Touch control issue

Model	PNC	PROD NO
EBC54503AX	942401200	0132272062
EBC54503OX	942401201	0132272063
MC463XE	942401202	0132272064

DATE: 2014-10

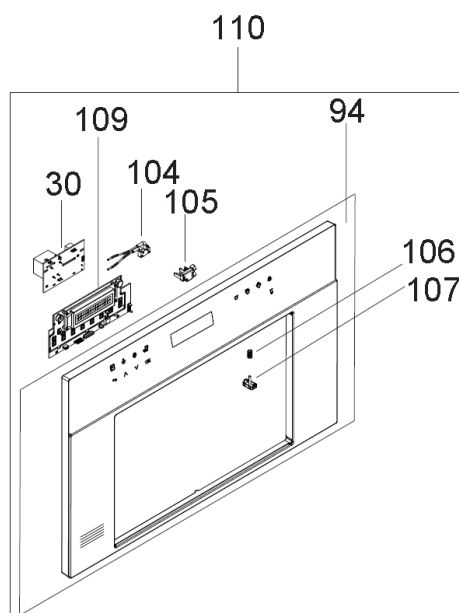
We inform You that, in the models above described, if You find any malfunction of the touch screen in the normal use of of the machine, eg for quitting the stand-by mode (there is no answer after used the touch commands), to solve the problem, it's necessary to replace the whole subgroup frame assembly (in the position 110 of the exploded view, look at the above drawing), with the spare part number:

- 1) **4055307278** for the type MC INT ELUX EBC54503AX-942401200 - 0132272062
- 2) **4055307286** for the type MC INT REX MC463XE-942401202 - 0132272064
- 3) **4055307294** for the type MC INT RU ELUX EBC54503OX-942401201 - 0132272063
